GDS Associates, Inc.

**Review of the Empire District  
Electric Company's 2010  
Utility Resource Filing Pursuant  
to CSR 240 - Chapter 22  
(Case No. EO-2011-0066)**

**For the Missouri Department of Natural  
Resources**

12/28/2010

Figure 2 shows how Empire compares with other utilities in the US.

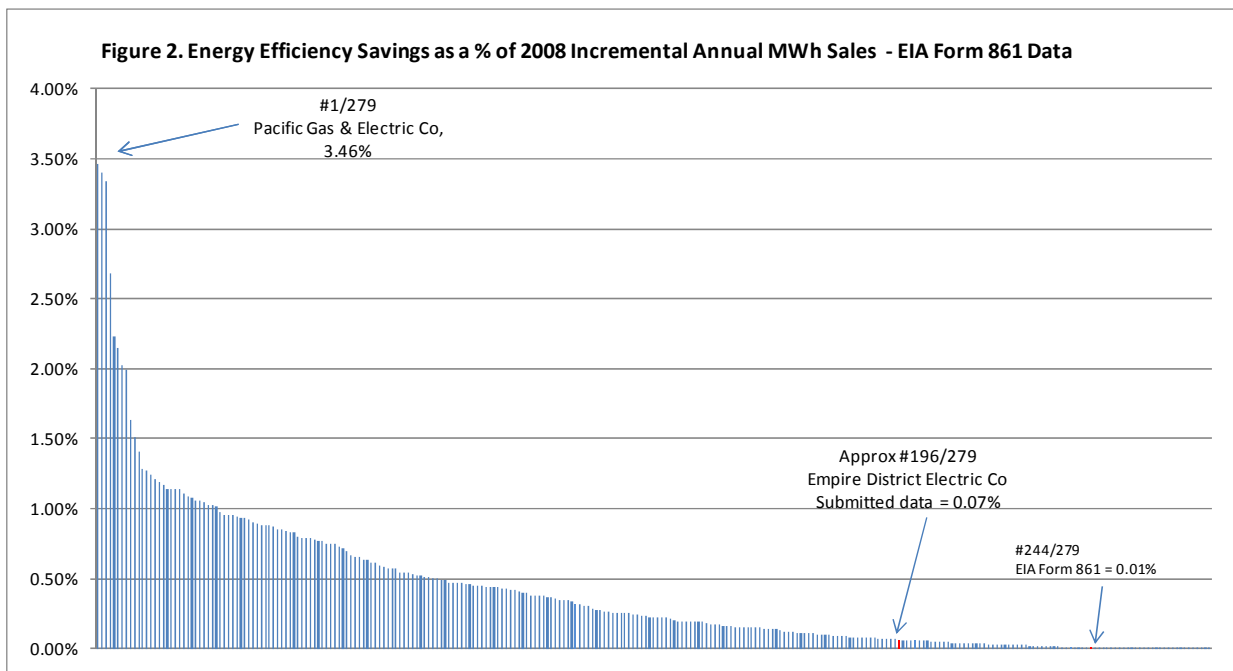
Given the target DSM budget that Empire specified, the Company's IRP filing does not depart from its past level of performance. Based on the data provided by Empire, the annual amount of energy efficiency savings that it expects to obtain in the future ranges between \*\* [REDACTED] \*\* and \*\* [REDACTED] \*\* of its annual kWh sales (before reduction for DSM). In the utility's preferred resource plan (Plan 4), Empire would implement conservation programs that would save about \*\* [REDACTED] \*\* of its annual kWh sales.

**Figure 3. Potential Savings from Energy Efficiency (mil. kWh)**

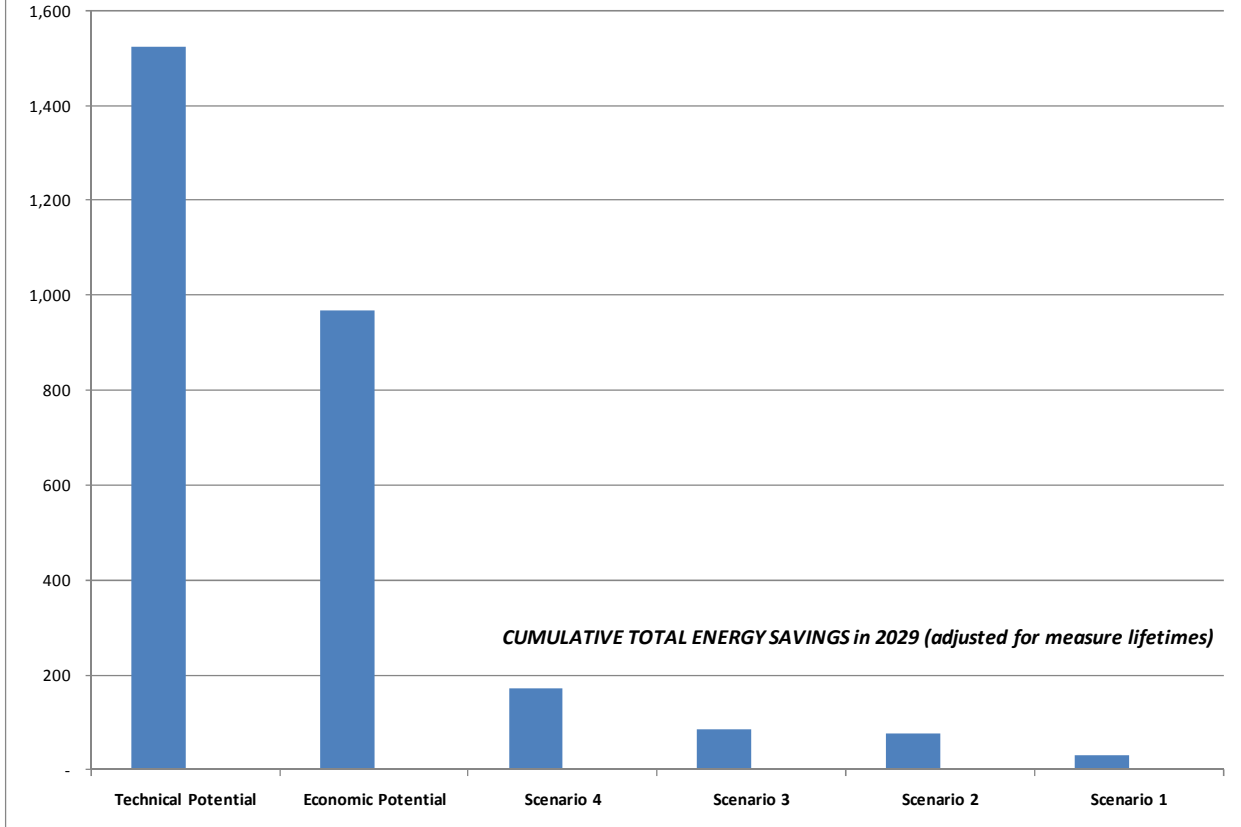
Figure 3 (Highly Confidential in its entirety) places the cumulative amount of energy savings achieved in 2029 within the context of the technical and economic potential that AEG has estimated for Empire. To say that least, a substantial amount of energy efficiency savings potential is left unaddressed in Empire's resource plans.

Empire has constrained program penetration to impact and spending levels comparable to the low levels accomplished in the past. Empire did not allow its IRP models to consider more energy efficiency when it was cost effective and passed the TRC test. The Company’s approach has limited customer participation to rates achieved in the past even though there is a significant amount of energy efficiency potential available for the models to select if a true bottom-up methodology was used in the study (see Figure 3).

Figure 4. Percentage of 2008 Revenues Spent on Energy Efficiency - EIA Form 861 Data

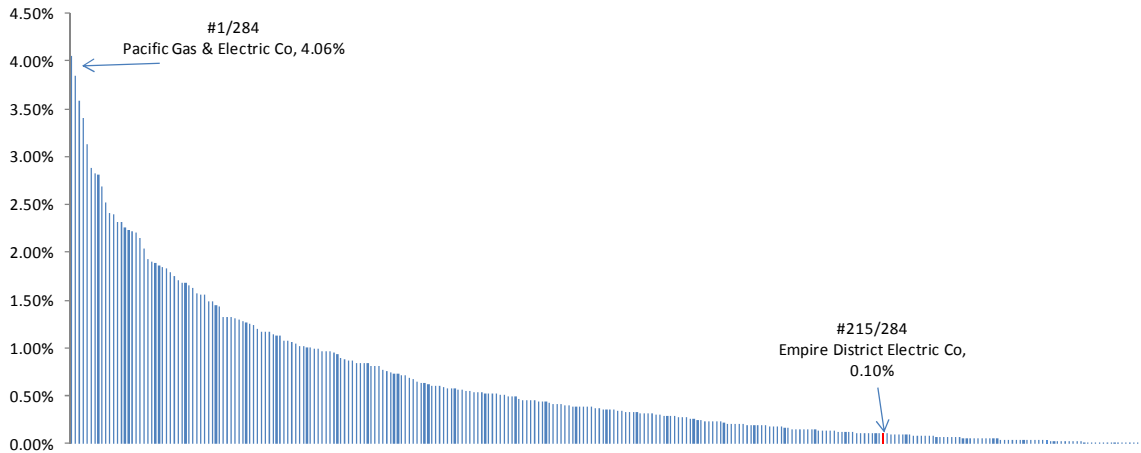
It is also worth repeating that the DSM budget was constrained to be no higher than 1% of Empire's 2009 electric revenues. With regard to the percentage of revenue spent on energy efficiency, garnered from the 2008 EIA Form 861 data, Empire ranks 215<sup>th</sup> out of 284 reporting utilities (see Figure 4). In 2008, Empire spent only 0.10% of revenues on energy efficiency programs. In contrast, the top 20 utilities by this metric spend over 2% of revenues on energy efficiency programs (see Table 6). According to the same 2008 data, North Central Missouri Electric Cooperative ranked 7<sup>th</sup> among utilities, spending a reported 2.82% of revenues on conservation programs.
